Project	IEEE 802.16 Broadband Wireless Access Working Group < http://ieee802.org/16 >
Title	Clean-up Text for HARQ Feedback A-MAP (15.3.6.3.2.3)
Date Submitted	2009-11-06
Source(s)	Hyunkyu Yu <i>Samsung Electronics</i> hk.yu@samsung.com
Re:	Comments on IEEE P802.16m/D2 for IEEE 802.16 Working Group Letter Ballot Recirc #30a
Abstract	The contribution proposes text changes for IEEE P802.16m/D2 in Section 15.3.6.3.2.3 (HF-A-MAP)
Purpose	To be discussed and adopted by the IEEE 802.16 Working Group
Notice	<i>This document does not represent the agreed views of the IEEE 802.16 Working Group or any of its subgroups. It represents only the views of the participants listed in the "Source(s)" field above. It is offered as a basis for discussion. It is not binding on the contributor(s), who reserve(s) the right to add, amend or withdraw material contained herein.</i>
Release	The contributor grants a free, irrevocable license to the IEEE to incorporate material contained in this contribution, and any modifications thereof, in the creation of an IEEE Standards publication; to copyright in the IEEE's name any IEEE Standards publication even though it may include portions of this contribution; an

Figure 514—Chain of HF-A-MAP IE to HF-A-MAP symbols

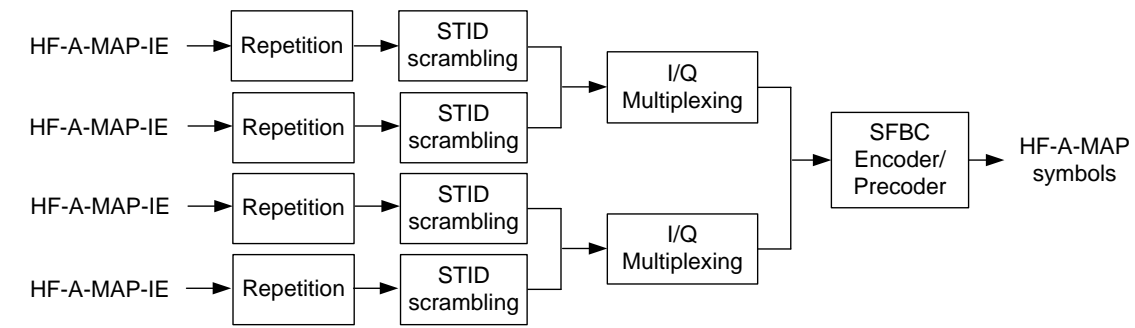
Figure 514 shows the construction procedure of HF-A-MAP symbols from HF-A-MAP-IE.

~~Each HF-A-MAP-IE carries 1 bit information. Depending on the channel conditions, the modulation can be QPSK or BPSK. If QPSK is used, 2 HF-A-MAP-IEs are mapped to a point in the signal constellation. If BPSK is used, each HF-A-MAP-IE is mapped to a point in the signal constellation. The repetition number, $N_{\text{Rep, HF-A-MAP}}$, is 8. Repeated HF-A-MAP-IE bits are scrambled by the $N_{\text{Rep, HF-A-MAP}}$ LSBs of the STID of the associated AMS.~~

Each HF-A-MAP IE carries 1 bit information. Firstly, it is repeated $N_{\text{Rep, HF-A-MAP}}$ times, where $N_{\text{Rep, HF-A-MAP}}$ is 8. Then, Repeated HF-A-MAP IE bits are scrambled by the $N_{\text{Rep, HF-A-MAP}}$ LSBs of the STID of the associated AMS. Depending on the channel conditions, power scaling can be applied to each scrambled sequence. Before MIMO encoding, each scrambled sequence is mapped to either real part or imaginary part in the signal constellation and multiplexed with other scrambled sequence, if exist.
